Integrated Nuclear Services

JHT/96-46
July 15, 1996

Subject: Supplementary Information to FTI's Response to NRC's Request for Additional Information on BAW-10168, Volume II, Revision 2, October 1992; RSG LOCA - BWNT Loss-of-Coolant Accident Evaluation Model for Recirculating Steam Generator Plants.

Fig. 3

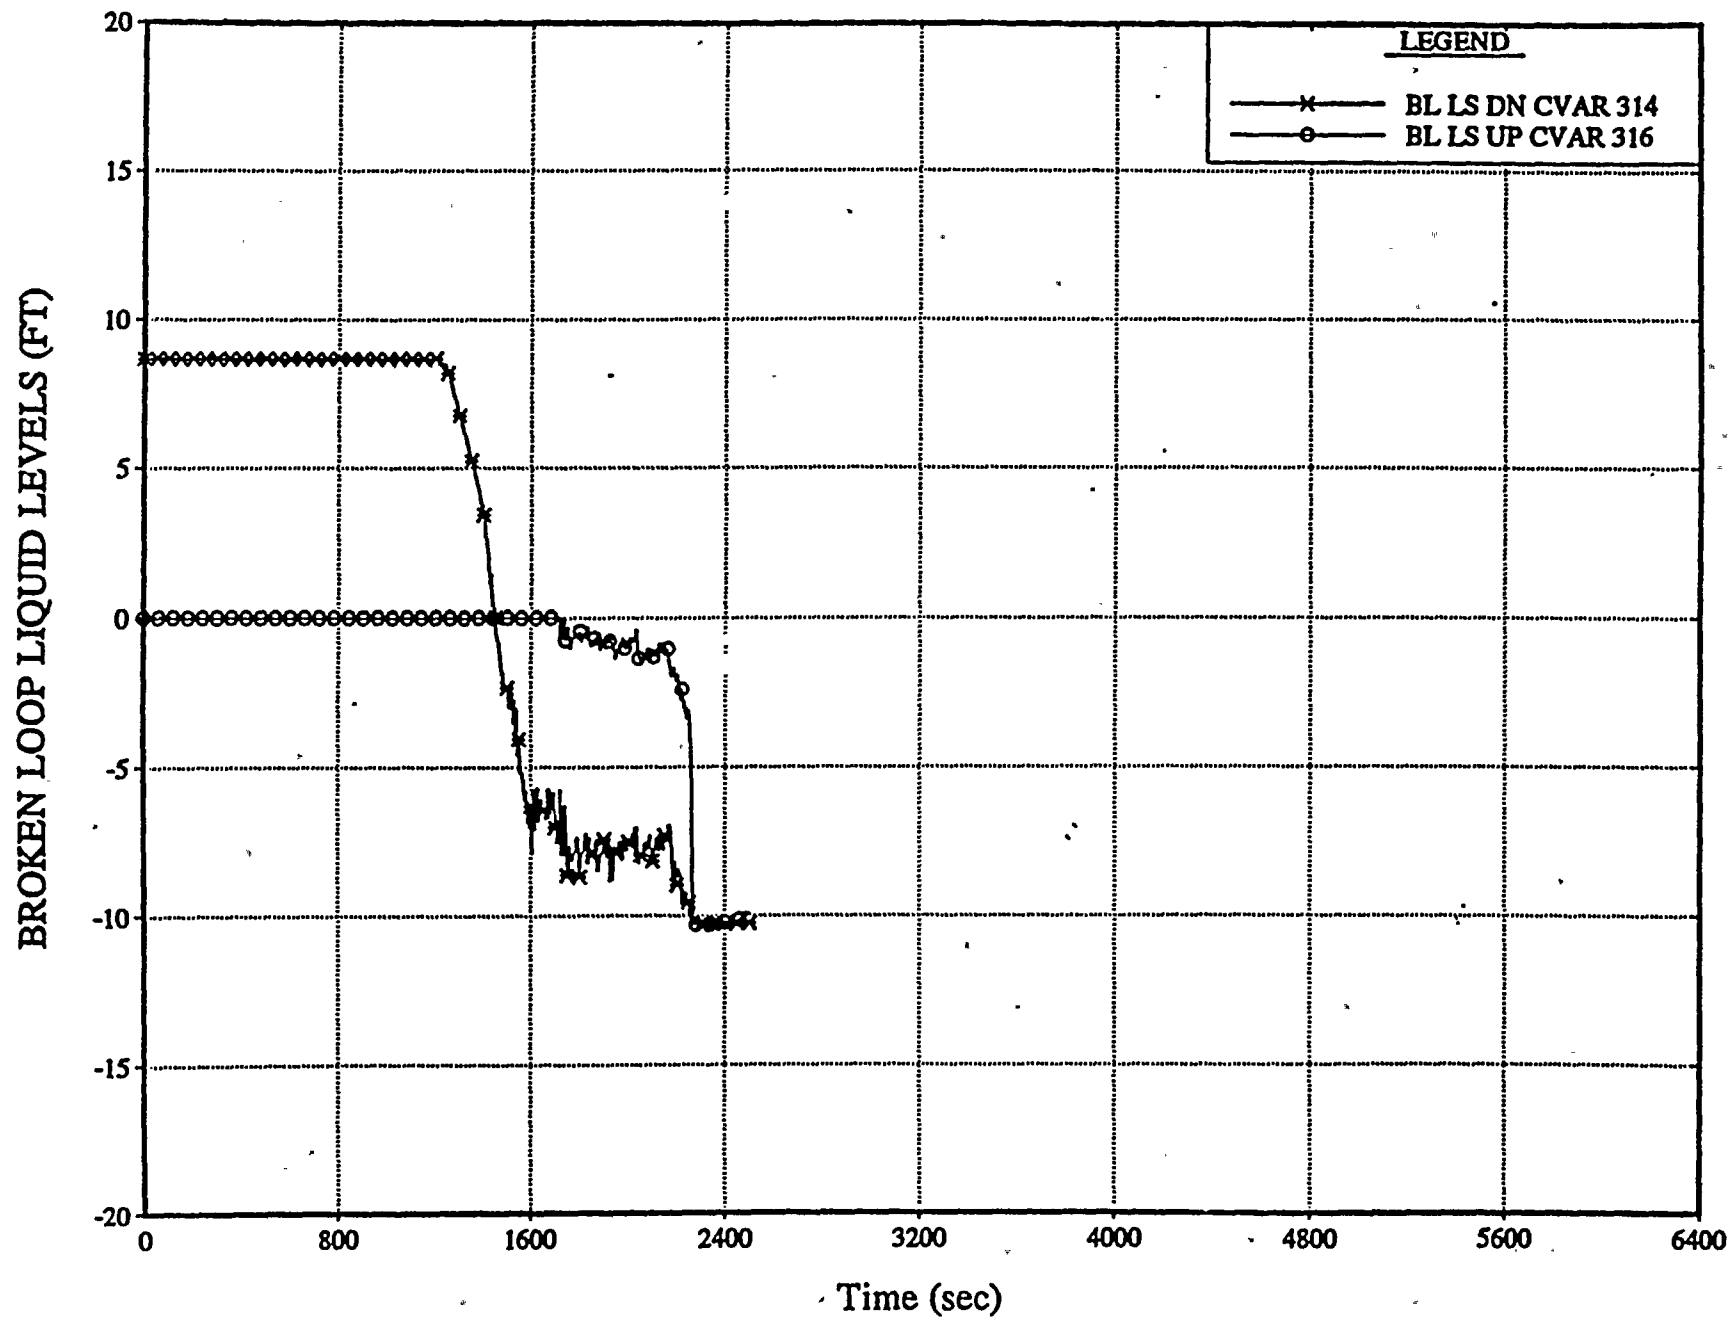
Figure 3 shows that the liquid level in the upside of the loop seal section starts to decrease after about 1700 seconds. The void fractions in Nodes 255, 260, and 265 are shown in Figures 6 through 8, respectively. From these figures it can be seen that the liquid level decrease in the loop seal upside section is caused by the increase in void fraction in the pump volume (Node 260). Steam venting from the loop seal occurs only after about 2200 seconds as shown in Figure 6. The pump discharge piping on the other hand is highly voided after about 750 seconds due to the steam flow from the upper head spray nozzles into the downcomer. At about 1600 seconds the break junction void fraction increases rapidly from zero to a highly voided state and the flow in the cold

FIG 5

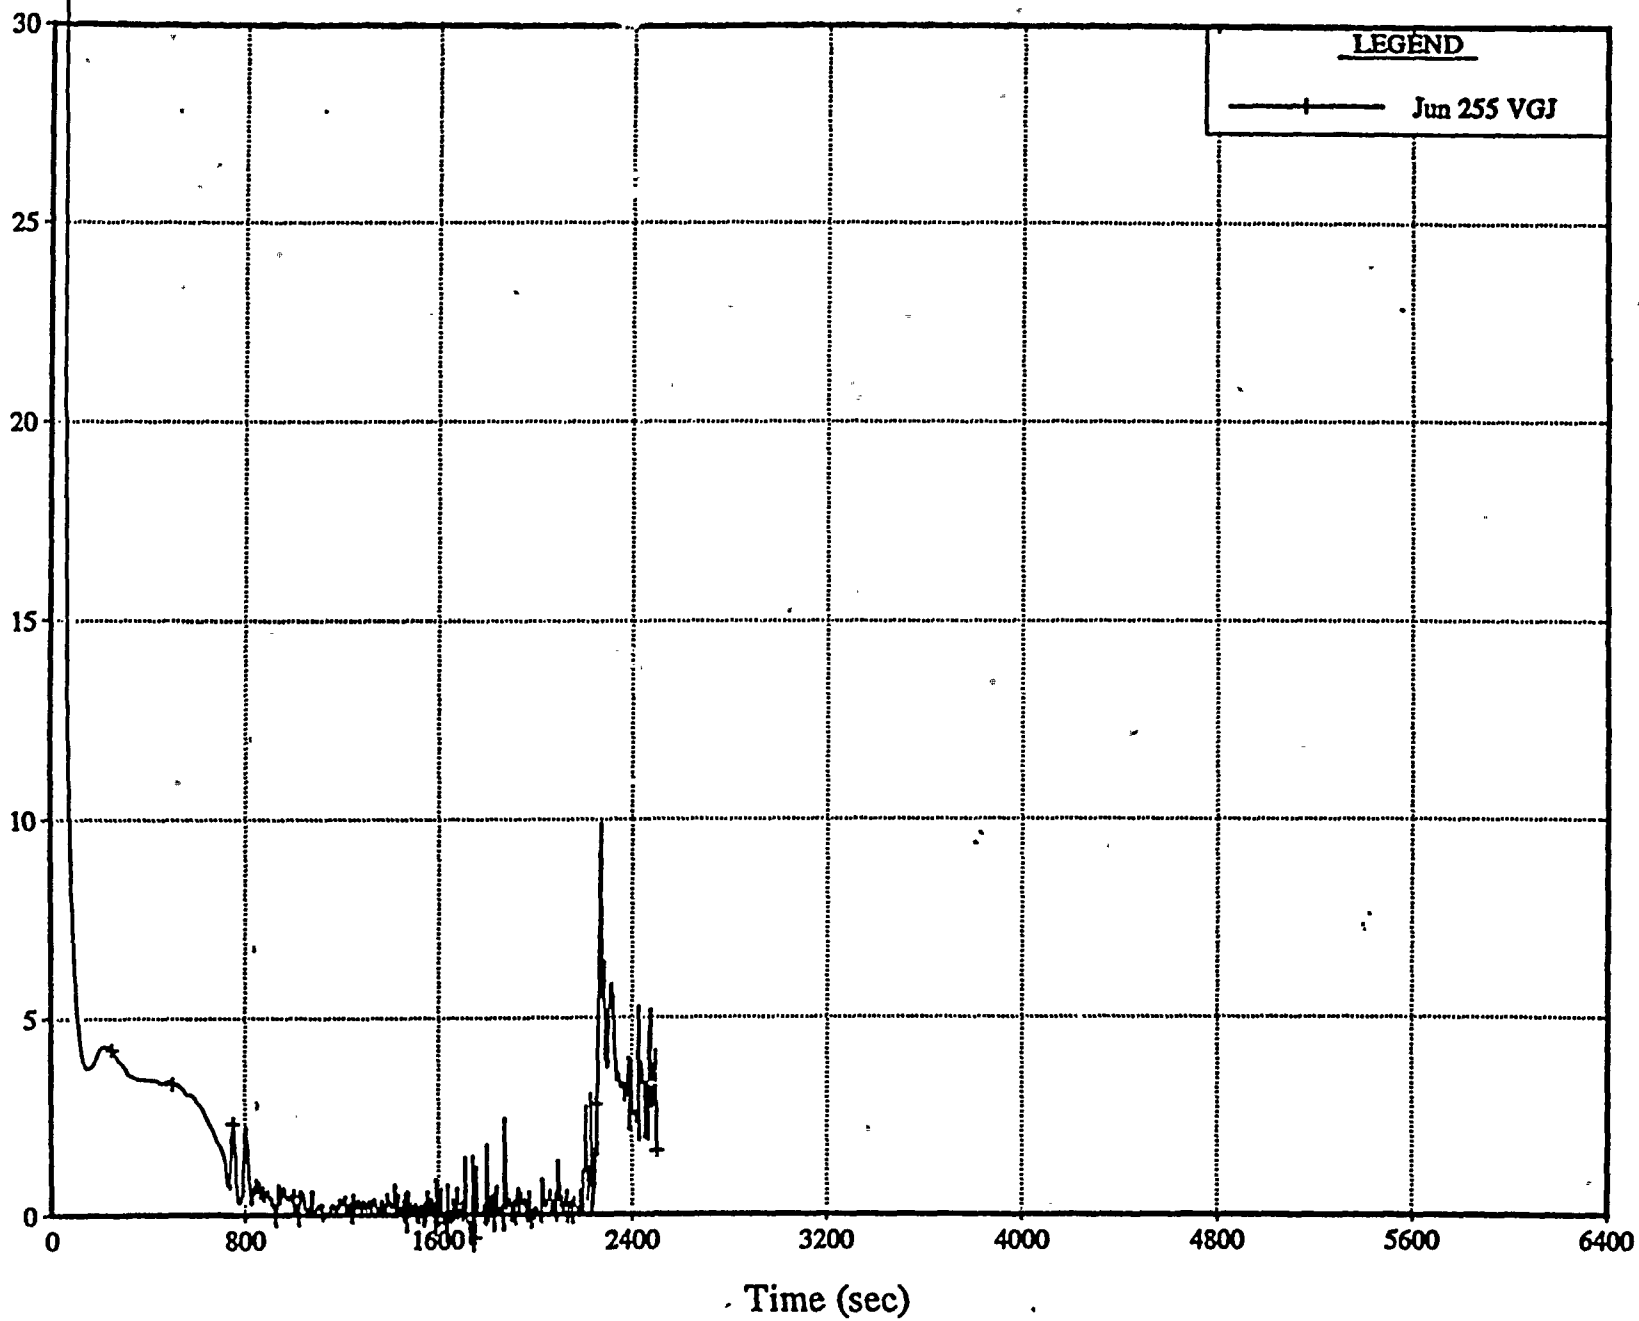
The steam velocity in the upside pump suction piping for the 2-inch break is shown in Figure 5. Once the steam venting process initiates, the head imbalance in the loop seal accelerates the steam flow and can be expected to reach a terminal velocity sufficient to clear the loop seal. For the 2-inch break the terminal steam velocity in the upside pump suction piping reaches about 10.0 ft/s at the time of loop seal clearing as shown in Figure 5. Tuomisto and Kajanto¹ show that the loop will clear completely for steam velocity greater than 6.2 ft/s (1.9 m/s) at 870 psia (60 bar). This is based on the flooding criterion for large diameter vertical pipes, Kutateladze Number Ku (See Equation 5 in Reference 1) equals 3.2. This flooding criterion is defined as a zero downward flow of falling film on the tube surfaces. They also show that, at pressures above about 145 psia (10 bar), vertical flooding is the limiting mechanism for loop seal clearing rather than the droplet entrainment from the stratified liquid in the horizontal section of the loop seal. For the 2.0-inch break case, the system pressure is about 1000 psia and therefore the loop will clear for steam velocities lower than 6.2 ft/s. The 1.9-inch break case in ROSA (see response to Question 14) demonstrates the loop seal clearing mechanism discussed above. For these break sizes, it is possible to accumulate some of the liquid in the loop seal once the initial acceleration of steam is complete as observed in the test. This liquid fall back is also observed in the RELAP5 simulation of the 1.95-inch break case which is discussed at the end of this section.

Figure 10: Typical FTI SBLOCA 4-Loop RSG Pump Suction Noding Details

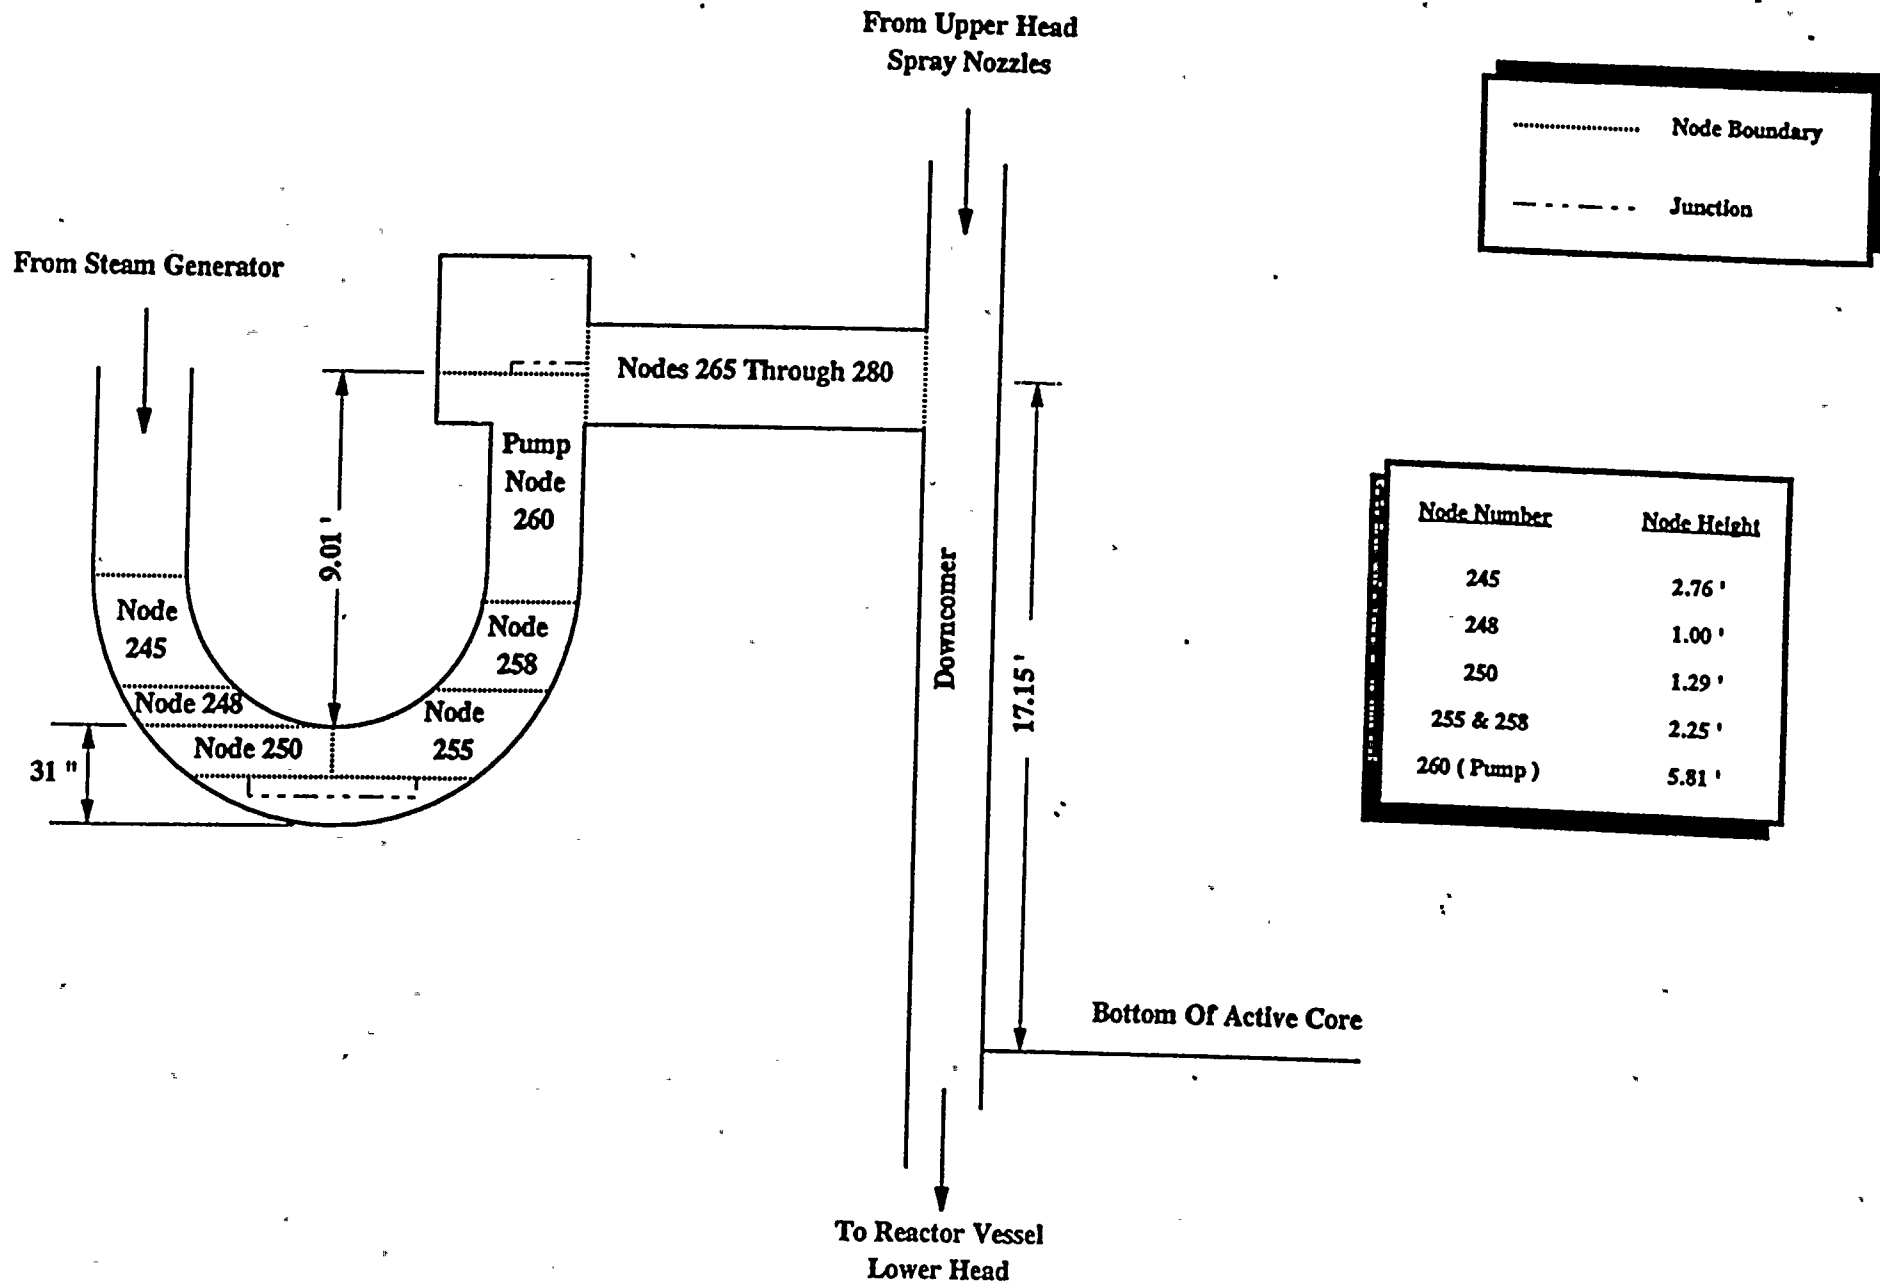
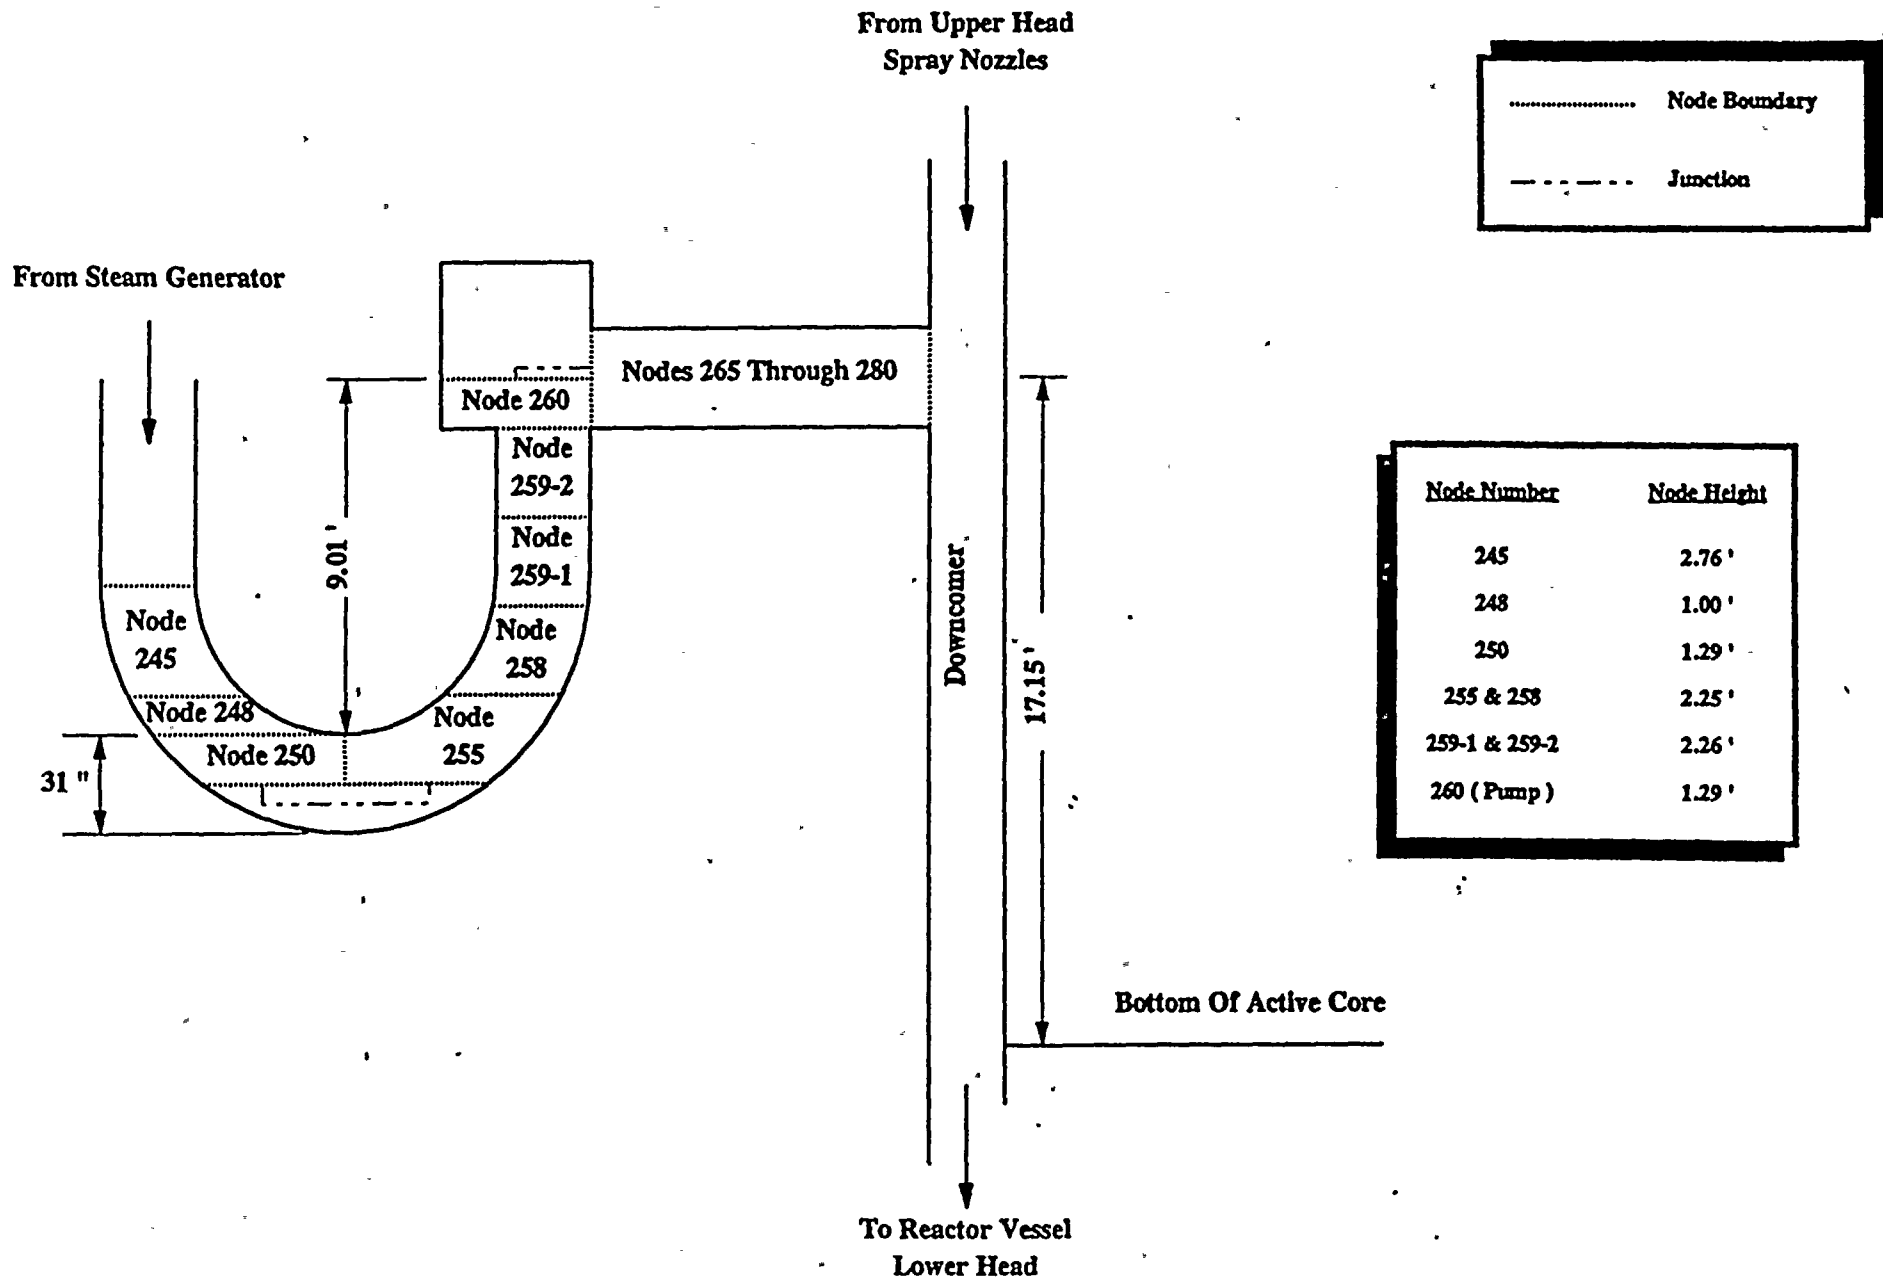
The broken loop pump suction noding for the base model is shown in Figure 10. To reduce early loop seal clearing, Node 248, representing the lower portion of the downside piping, was set at a small node height, 1 foot. The bottom of Node 248 coincides with the spill under elevation of the loop seal. Node 250 represents the horizontal portion of the U-bend and the height of this node is the radius of the pipe. Node 260 represents the pump. The height of Node 260 is 5.81 ft which is the actual height of the pump up to the centerline of the discharge piping. In RELAP5, the pump volume also uses the high mixing flow regime, and, therefore, slug flow (Wilson drag) is not used in this node, even though it is a vertical node.

The early voiding of the pump node for the 2.0-inch break case, as discussed in the previous section, may have been caused by the height of Node 260. To study the sensitivity of pump node size, the base input model was modified by dividing the pump volume into three nodes (259-1, 259-2, and 260) as shown in Figure 11. Node 260 still represents the pump. In this case the 2.0-inch break case did not clear the loop seal. For a 2.1-inch break case, the loop seal cleared after about 3300 seconds. Collapsed liquid levels in the loop seal and core and the void fractions in the loop seal nodes, pump node, and the pump discharge node of the broken loop are shown in Figures 12 through 22. From these figures the following observations can be made. Steam venting through the loop seal starts after Node 245 is highly voided. This occurs at about 1400 seconds. The void fraction in Node 259-1, which is part of the actual pump, is close to the void fraction in Node 258. Node 260 is highly voided and the void fraction in node 259-2 is somewhere between the values for Nodes 259-1 and 260. The void distribution in the upside U-bend, including the pump volume, is improved over that in the base calculation. The venting of steam causes the liquid level in the upside of the U-bend to decrease, reducing the core level depression. Figures 12, 14, and 15 show liquid level oscillations on the order of 1.0 foot in the down side of the U-bend from about 1500 seconds until the time of loop seal clearing, about 3300 seconds. The oscillations are mainly caused by the condensation of steam on the cold ECC water

The revised pump nodding will be used in SBLOCA EM. However, this model change does not impact previous EM studies and benchmarks.
